Title:	Service Note Connector Motor Cards				ID:
					0014
Date in:		Response:	Model:	Author:	
2005-12-03		2005-12-03	-	СМа

## **Service Note**

## **Connector Motor Card**

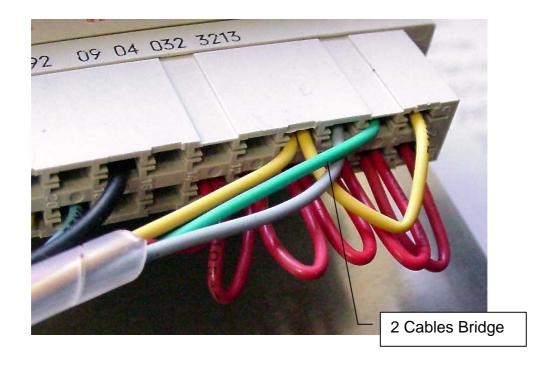
Crimp Contact were taken that are not suitable for two cables.

The metal core of one of the two cables may be broken.

Suitable pins were purchased. Contact pins on all modules on stock will be replaced.
